**Subject:** [EXTERNAL] RE: BC & D Operating - Javelina 26-25-37 SWD #1 Application

## PROPOSED WELL SCHEMATIC

Javelina 26-25-37 #1 32.10810, -103.14160 NAD83

Figure 3. Proposed Javelina 26-25-37 #1 well schematic Released to Imaging: 8/22/2023 9:35:37 AM

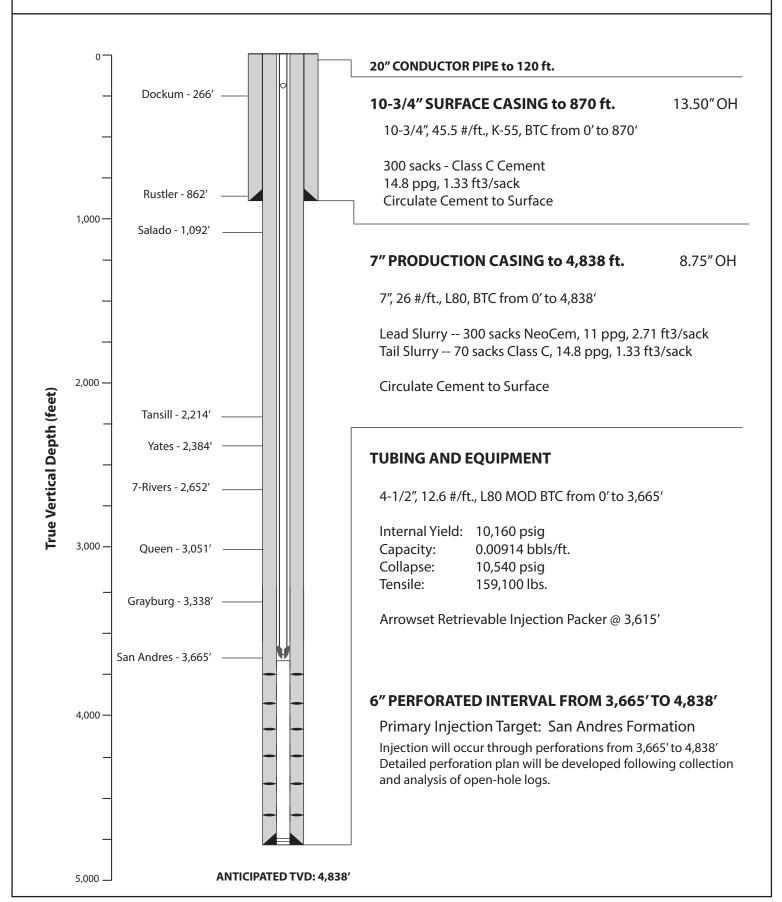
I have picked up this review with the departure of Alana. She was able to get the additional information from Geolex to complete the application following the technical review. However, in my review for the final order preparation I note that an "open-hole" completion for this San Andres disposal well. OCD no longer approves open-hole completions except for Silurian-Devonian wells where the confining layer is a shale. Additionally, the open-holes approved under prior administrations for San Andres have resulted in waterflows in this formation which interferes in drilling/completions, fails to protect correlative rights especially in areas with waterflood operations (Hobbs outflow), and offers no downhole control should zone isolation be required. Therefore, if BC

& D Operating wishes to proceed with the approval of the disposal well, the OCD require the extension of the production casing to TD with perforations for injection. Please contact your client and, if they concur, provide an updated wellbore diagram with the change in construction. Please contact me with any questions. PRG

Per your request (see correspondence below), please find a revised well schematic for the Javelina 26-25-37 SWD #1 application. As you discussed, we have revised the design to implement a cased-hole completion with injection occurring through perforations.
